**DEFENSE NUCLEAR FACILITIES
SAFETY BOARD**

HANFORD TANK FARMS SAFETY BASIS REVIEW

Defense Nuclear Facilities Safety Board Technical Report

SEPTEMBER 2021

Figure C-1. Mass of respirable waste released from a DST by a headspace detonation that causes dome failure. Recreated from Figure C-16 in [C-4].

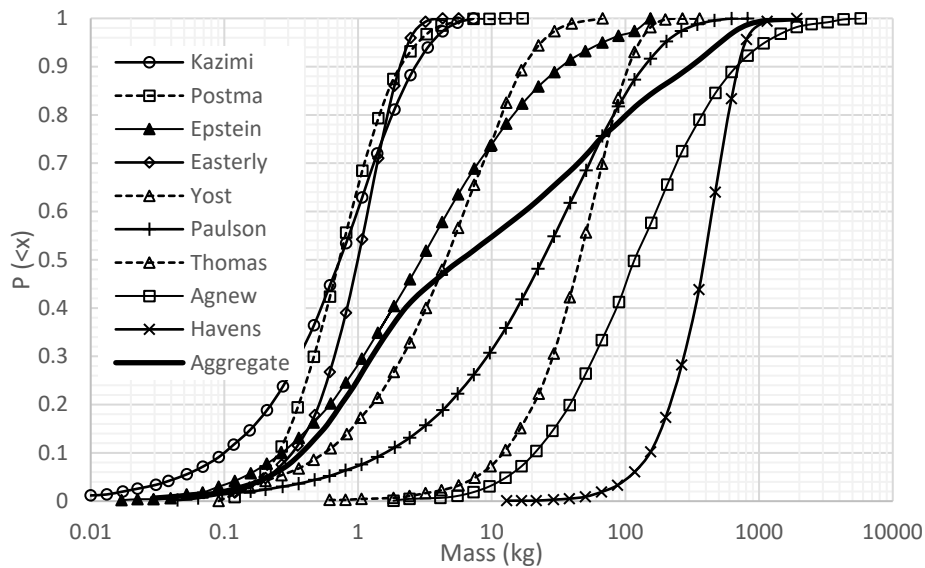
Expert Elicitation Results. The technical bases for the analyzed doses are documented in [C-2] and [C-3]. A key input into the calculations is the amount of respirable mass released as a result of a detonation or deflagration in a vessel headspace. To estimate these releases, an expert elicitation process was used. Figure C-1 below shows an example of the estimated respirable mass released due to a detonation in the headspace of a DST that results in the vessel dome failing [C-4]. Probability distributions elicited from nine experts are shown. The solid curve is the aggregate mean of the nine distributions. The vertical axis is the estimated probability that the actual value of mass released is less than a given mass on the horizontal axis. Similar curves were generated for flammable gas accidents in SSTs for which seven experts were elicited [C-5]. The DSA utilizes these aggregate mean distributions for selecting values used in dose consequence analysis.

Figure C-2. Aggregate mean respirable mass suspended/released from a deflagration accident in Hanford Waste Tanks used for on-site dose consequence analysis in DSA. DST data recreated from Figure C-15 in [C-4]. SST data recreated from Figure A3-A16 in [C-5].

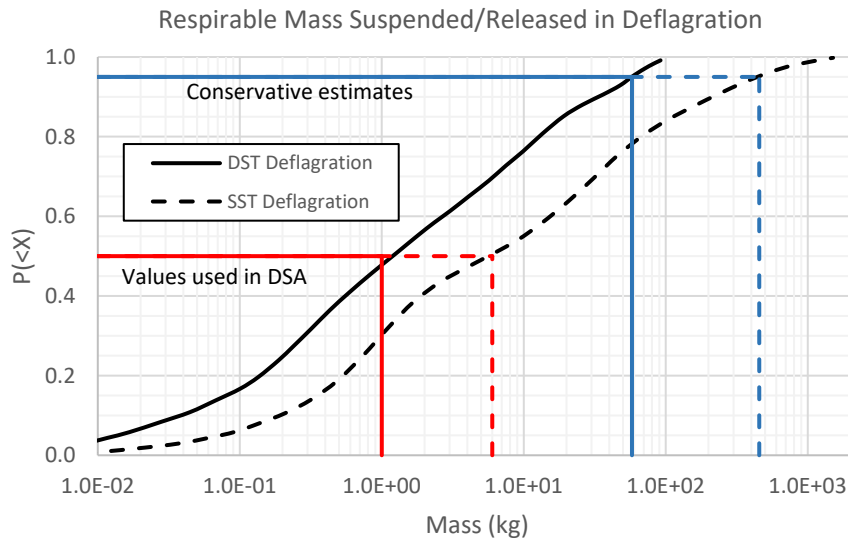
Figure C-2 below shows the expert elicitation results for aggregate mean mass released¹ for deflagration accidents in DSTs and SSTs. In applying this information to compute on-site dose estimates, the DSA used the 50th percentile estimated value of mass released. These are the

red lines shown in Figure C-2, corresponding to a mass of 1.0 kg for DSTs² and 5.7 kg for SSTs (which the DSA rounds up to 6 kg). The 50th percentile is the median value of a distribution and is typically considered to be the best estimate given an uncertain range of potential values. The masses corresponding to the reasonably conservative 95th percentile values of the median aggregate curves in Figure C-2 are 58 kg for DSTs and 455 kg for SSTs (blue lines in Figure C-2). These values are approximately 58 – 76 times larger than that the values used in the DSA.

Figure C-3. Aggregate mean respirable mass suspended/released from a detonation accident in a Hanford single or double shell tank from Figure C-16 in [C-4].

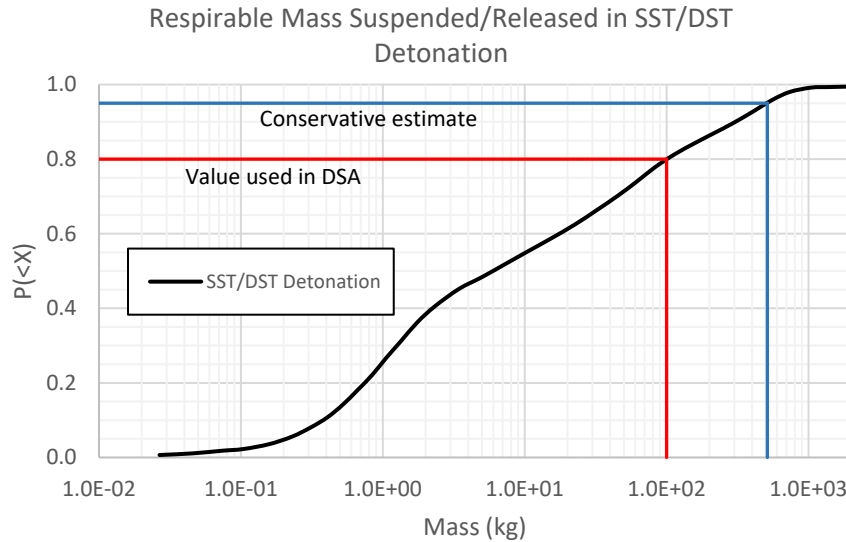
Figure C-3 below shows the aggregate mean respirable mass suspended/released for detonation accidents in an SST or DST. In applying this information to compute off-site dose estimates, the DSA used a mass of 100 kg, which is approximately the 80th percentile (the red line shown in Figure C-3) [C-3]. While the 80th percentile is a more conservative estimate than the 50th percentile used for on-site dose estimates, 20 percent of the potential values still exceed this value. The mass corresponding to the 95th percentile conservative estimate in Figure C-3 is 513 kg, which is about a factor of 5 higher than the value used in the DSA.

Figure C-4. Expert elicitation results for total mass suspended (left) and respirable fraction (right) for the deflagration accident in Hanford single shell tanks. From Figures A3-A16 and A3-A17 in [C-5].

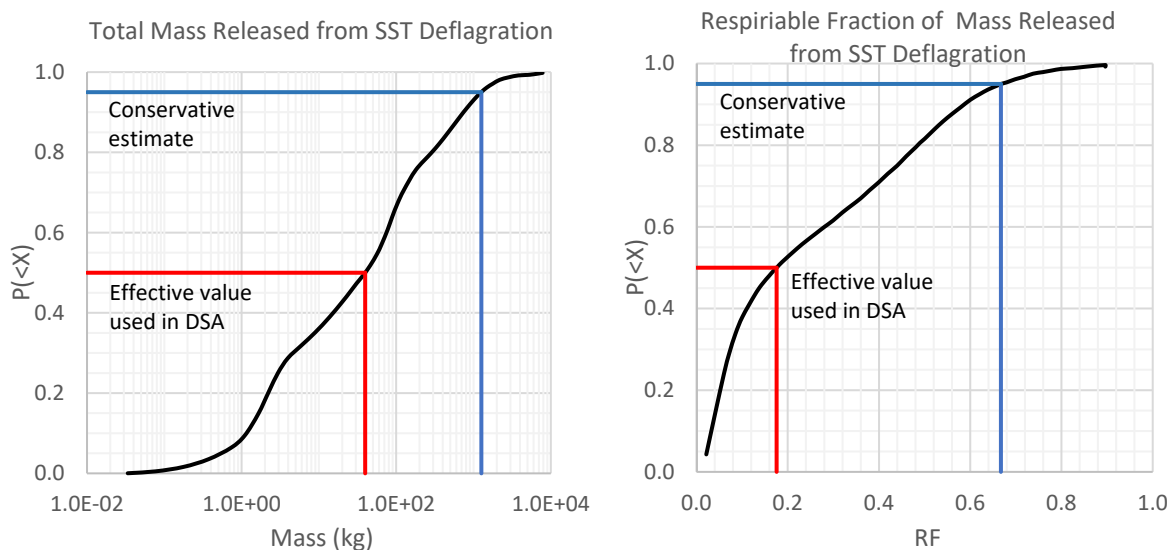
To illustrate the degree of non-conservatism resulting from using distributions for respirable mass, consider Figure C-4 below, which shows the individual distributions of total mass released and respirable fraction for deflagration events in SSTs. The respirable mass for this accident used in the DSA was shown in Figure C-2 to be 5.7 kg. The 50th percentiles for total mass released (40 kg) and respirable fraction (0.17) are shown in red in the Figure C-4. When these values are multiplied together, the respirable mass is about 6.8kg, which is close to the median value from the aggregate respirable mass distribution, suggesting the DSA effectively used median values for both total mass and respirable fraction. From Figure C-4, the 95th percentile conservative value of total mass released is 1260 kg, and the 95th percentile conservative value of respirable fraction is 0.67. A conservative estimate of respirable mass released is obtained by the product of these two conservative values³, resulting in a respirable mass released of about 840 kg. Note the additional conservatism in this result compared with the 95th percentile of the respirable mass distribution shown in Figure C-2, which was 455 kg. This additional conservatism is achieved when conservative values for each input parameter are selected, consistent with the requirements in DOE-STD-3009-1994.

A similar analysis could not be shown for DSTs since distributions for respirable fraction were not provided in the expert elicitation report [C-4]. The individual experts specified distributions of both total mass and respirable fraction, however aggregate mean distributions for respirable fraction were not provided in the report. Regardless, had the individual distributions for total mass and respirable fraction been published, it is clear that using conservative values for each would result in a more conservative (larger) amount of respirable mass, and subsequently a larger corresponding dose.
